W-1 LEON CREEK: HWY 151 TO HWY 90 - UPPER SEGMENT

Solicitation Number: CO-00351

Job No.: 19-4528

ADDENDUM 1

1 TEE-BASE FIBERGLASS MANHOLE DETAIL PLAN VIEW
N.T.S.

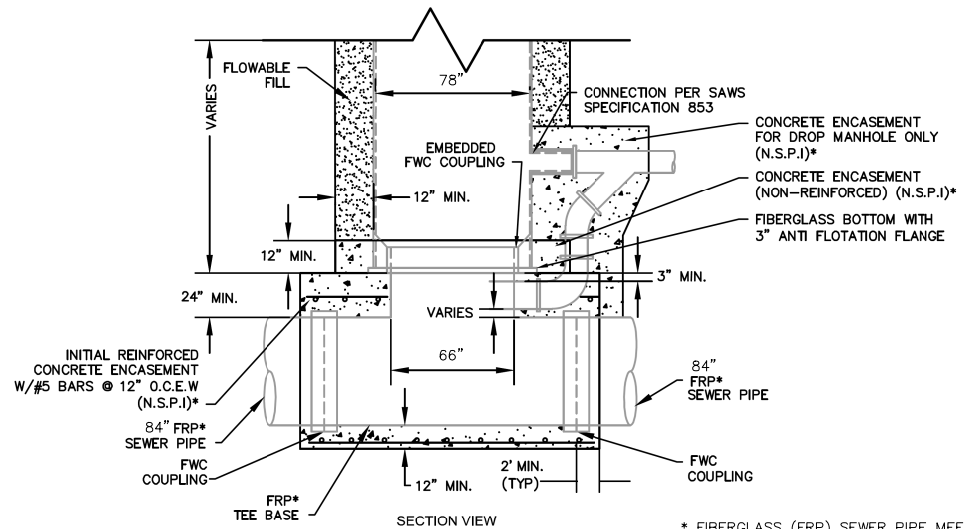
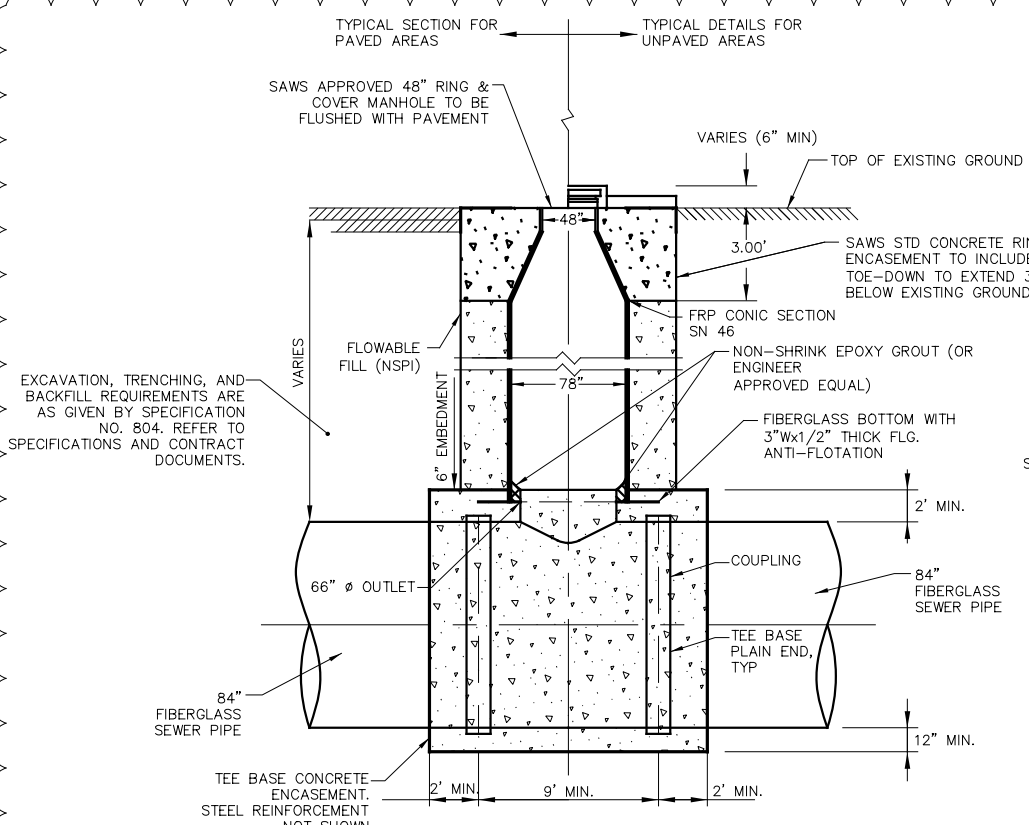
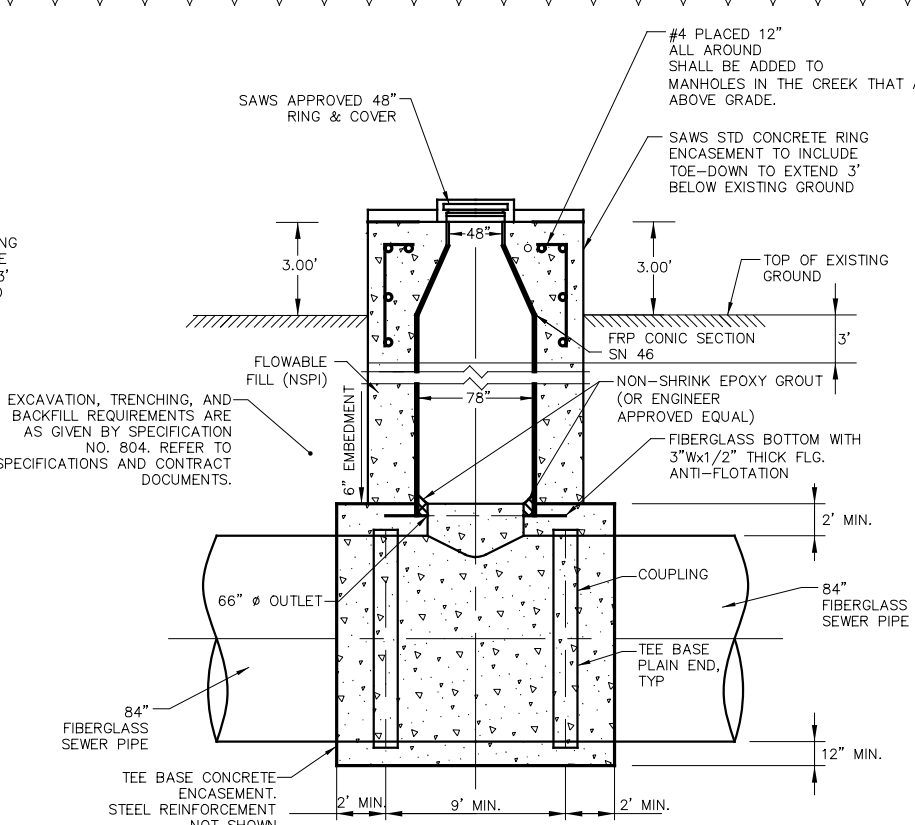
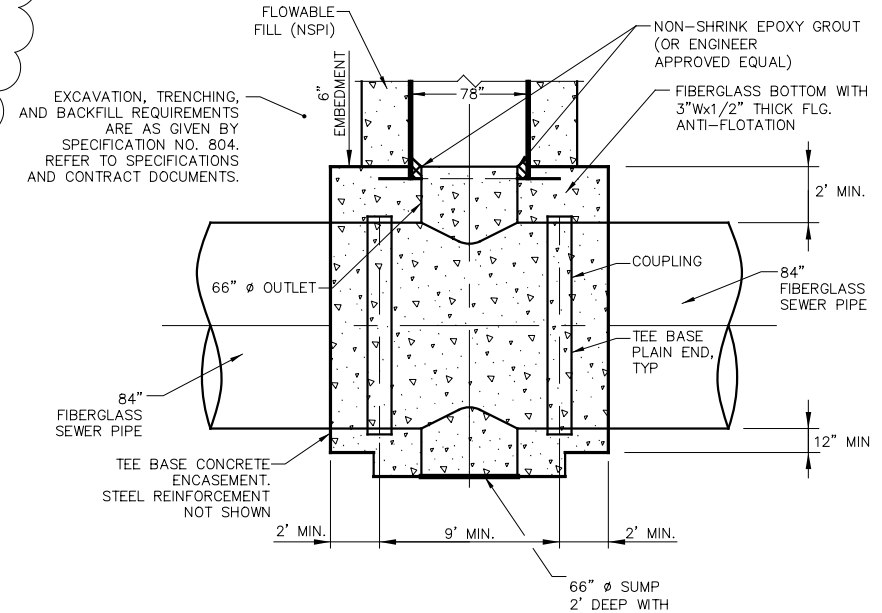
Q10: Please confirm which manholes will require the top slab as shown on D-5.A. Details on D-4 call out top slabs as “SAWS Standard Ring Encasement” with 3 foot toe down.

- Sheet D-4: Manhole Details, revised Manhole Section “A” – Replace sheet in its entirety.
 - Revised Detail D-4/1 Section A to show SAWS STD Concrete Ring Encasement

Response: *Manholes MH-1, MH-2, MH-3, MH-4, MH-8, MH-11, MH-14, MH-15 and MH-16 will require top slabs and reference Detail D-5/2. Detail D-4/1, Section A will be revised to show SAWS Standard Concrete Ring Encasement.*
